Docket Item # 3
BAR CASE #2008-0250

BAR Meeting
February 4, 2009

ISSUE: Approval of after-the-fact alterations

LOCATION: 329 North Washington Street

Figure 1: Photos from Applicant's Submission

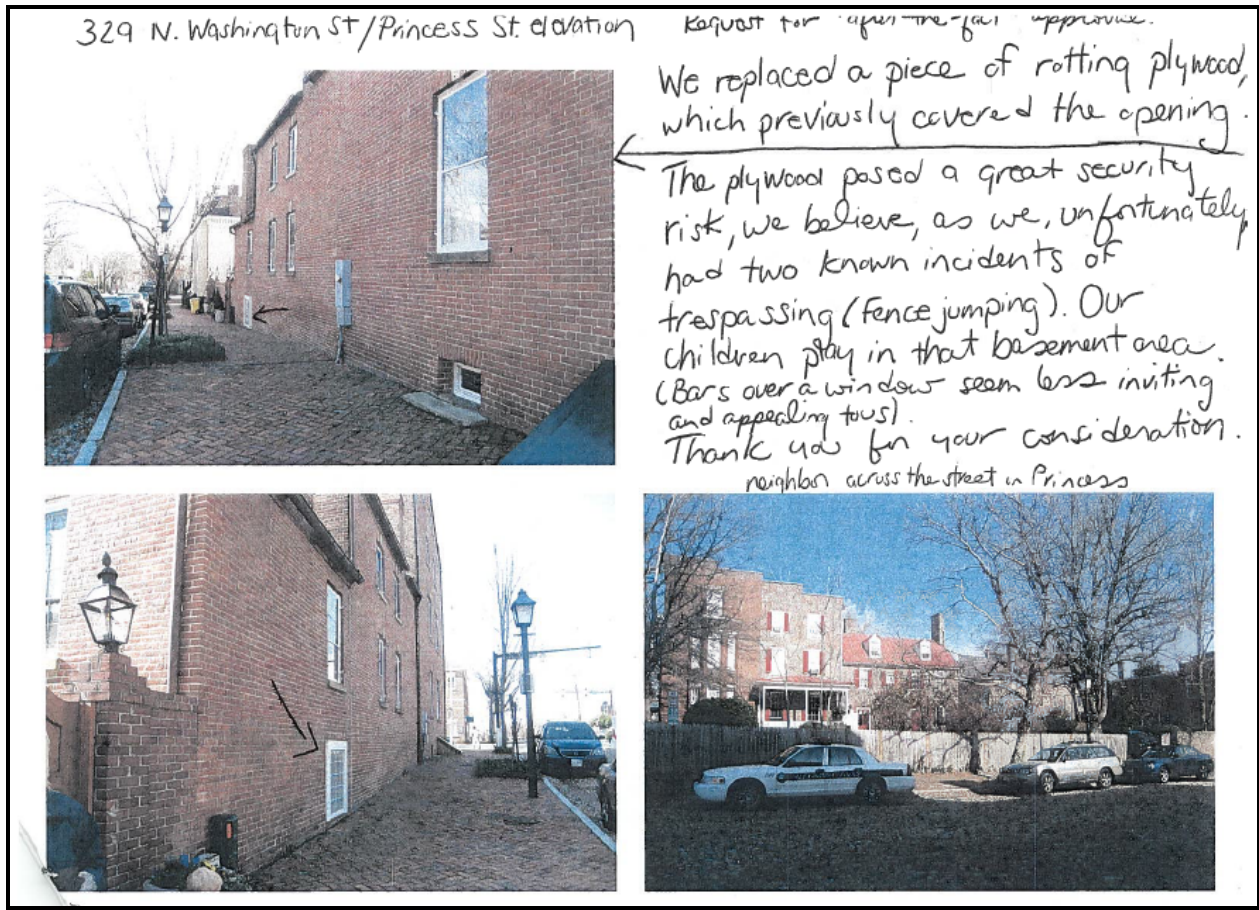
Staff objects to the after-the-fact installation of glass block to infill to the existing opening along Princess Street. After submitting the original application and at the request of Staff, the applicant modified the proposal to remove the glass block and install a double-hung, double-insulated wood window within the existing opening and retaining the existing trim configuration.

IV: STAFF RECOMMENDATION: Staff recommends denial of the after-the-fact glass block infill and approval of the six light, double-hung wood window with iron grille with the following conditions:

Figure 4: Proposed Double-Hung Window

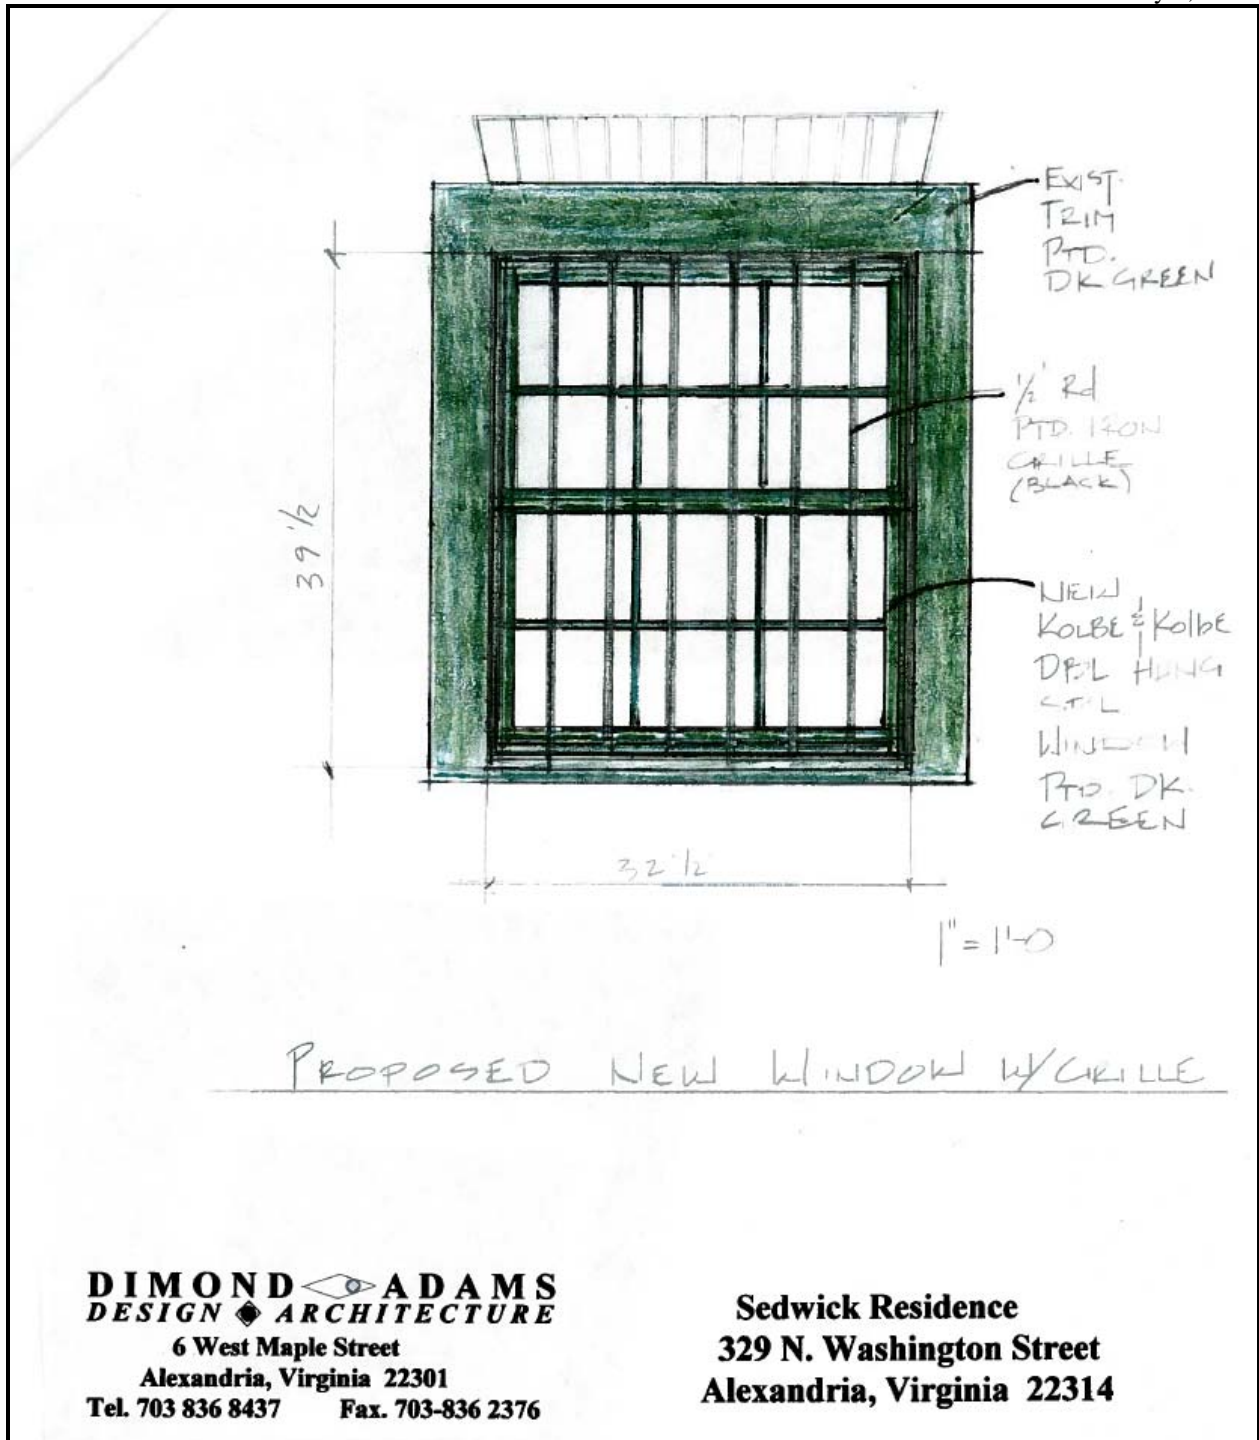
appropriate window. However, Staff does object to the use of a double-glazed window. Although the *Design Guidelines* and the Board generally allow for double-insulated, simulated-divided-light wood windows and doors on new construction or in areas with limited visibility, for visible locations such as this the *Guidelines* preferred window type is single-glazed, true-divided-light wood windows. With this window's location directly adjacent the street sidewalk, this window will be highly visible. In the opinion of Staff, the new window should be consistent with the other single-glazed windows installed throughout the historic portions of the house.

The applicant has indicated a willingness to reduce the width of the large trim surrounding the window, if feasible, as this gives the window an awkward and historically inappropriate appearance. In the opinion of Staff, the new window and security bars should be set within the masonry opening (unlike the glass block which is flush with the trim), and the trim surrounding it should be fit within the opening to match the other windows on the historic brick house. Staff should be afforded an opportunity to review and approve the condition of the brick surrounding the opening once the existing trim is removed, as well as the new trim that will be installed. Because of modifications that have been made to the masonry opening, this window may never look fully compatible with the other existing window openings. Staff believes that painting the window and trim a darker color will help to reduce the visual prominence of this opening.

3. That the window be single glazed with true-divided-lights;
4. That the applicant work with Staff to review the condition of the brick under the existing trim; that the applicant install the new window and associated security bars and trim inset within the masonry opening to the extent possible; and that Staff review and approve the final design of the new window trim to be installed.
